# Aguilar Subdivision Unit 1

City of El Paso — City Plan Commission — 12/6/2018

**SUSU18 - 00064 — Major Combination REVISED**

### PROPOSED (Pellicano)

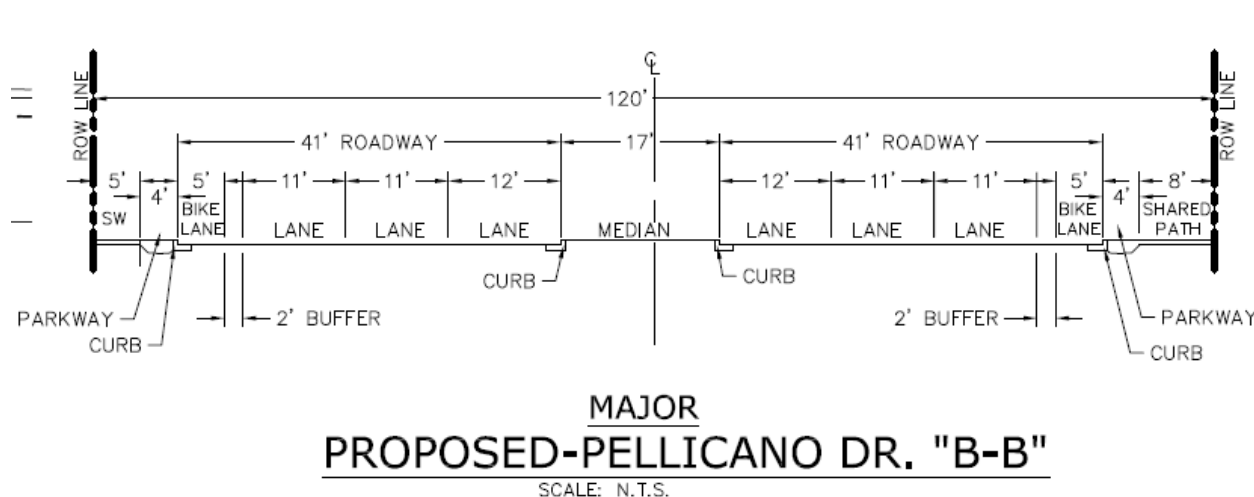
El Paso County will be constructing improvements to Pellicano above and beyond what would be required per the City's DSC. These improvements include 41' of roadway, a 5' bike lane, including a 2' buffer between the bike lane and the driving lanes, as well as a 5' sidewalk, and a 4' parkway. The proposed 4' parkway is 1' narrower than what is required and is the basis for the waiver request.

### REQUIRED (Joe Battle)

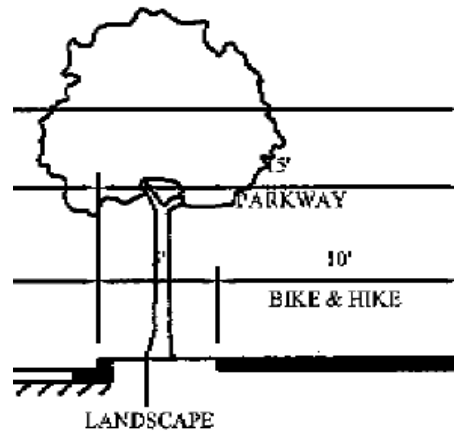
Joe Battle is classified as a freeway, while the City does not have jurisdiction over a freeway, the City does have purview over parkway improvements with concurrence from TxDOT, which staff has received (see TxDOT comments, pg. 14). The City's bike plan calls for a 15' parkway to include a 5' landscape buffer and a 10' hike and bike.

### PROPOSED (Joe Battle)

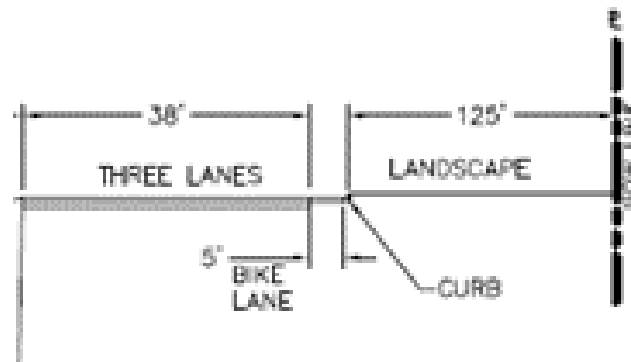
The applicant proposes to follow TxDOT requirements, which will only require a 5' sidewalk. However, the applicant is waiting on TxDOT's determination of whether or not a deceleration lane will be required before updating the cross-section to include a sidewalk. It should be noted that there is an existing 5' bike lane along Joe Battle.

TxDOT would not be opposed to a hike bike along Joe Battle should CPC deny the applicant's waiver request. TxDOT will require to leave the bike lane on Joe Battle as existing though, i.e., there will be a bike lane along the travel lanes to avoid having gaps if removed and the hike and bike and parkway between back of curb and right-of-way line.

## **ATTACHMENT 2**

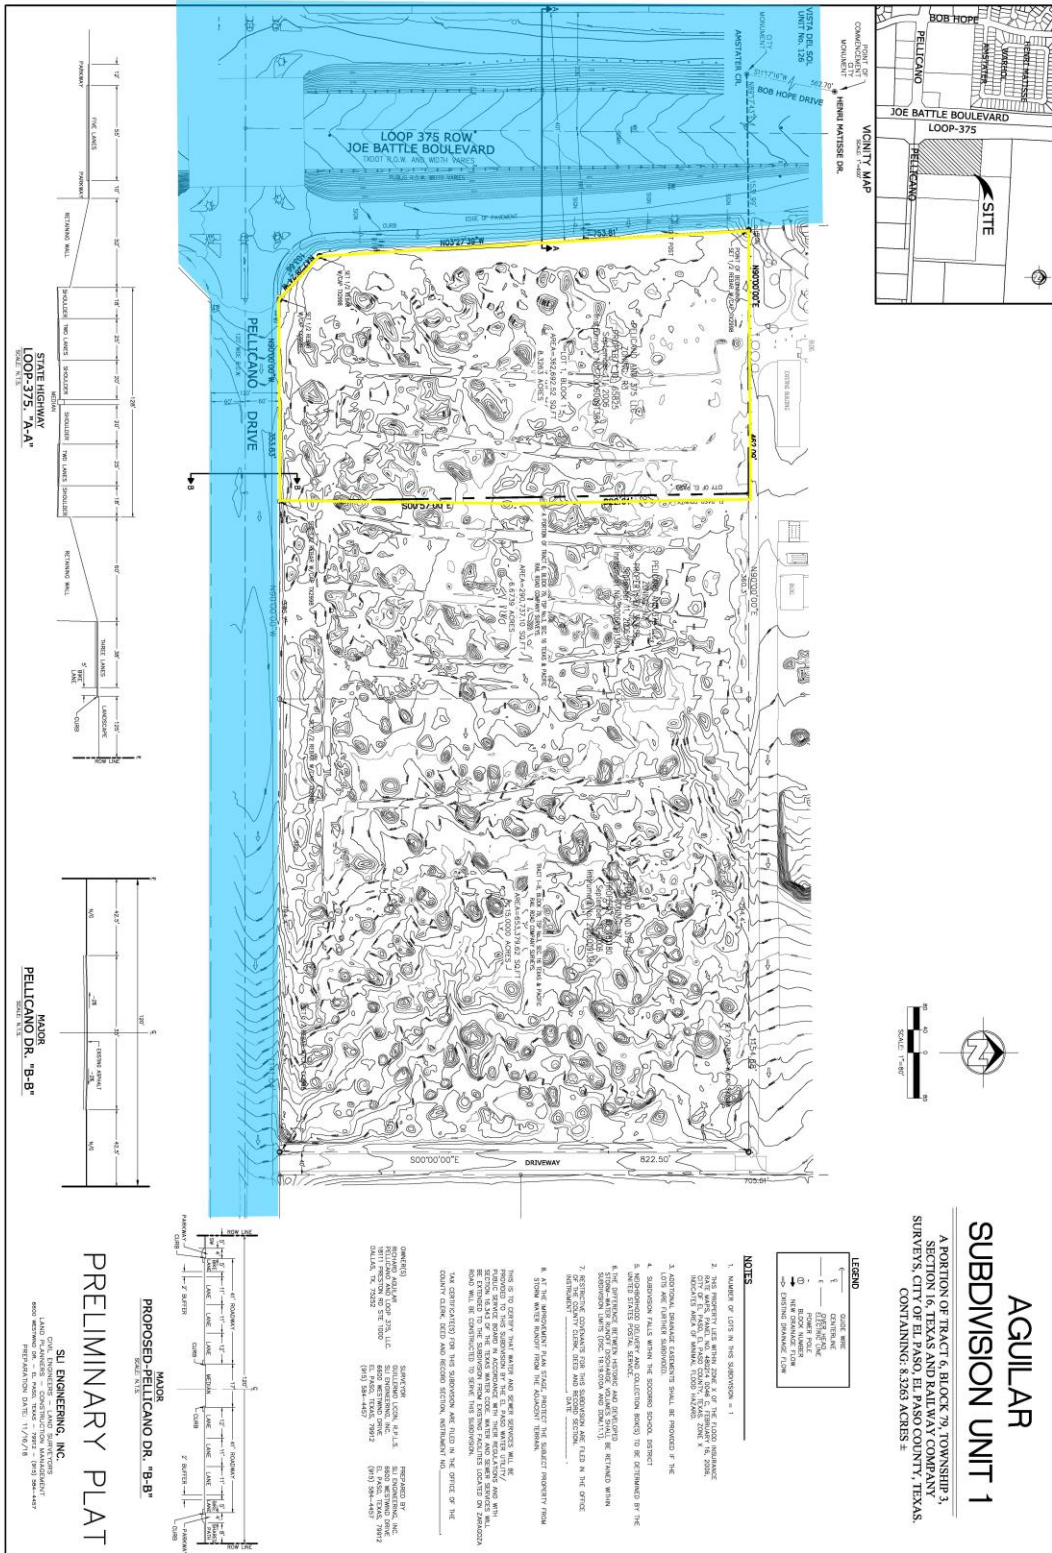
2. Show existing and proposed drainage flow patterns on the preliminary plat.

3. On the Preliminary Plat, show and label the proposed pond location within the lot. Any proposed ponding area shall have enough capacity to hold the developed runoff for a designed 100-yr. storm event.
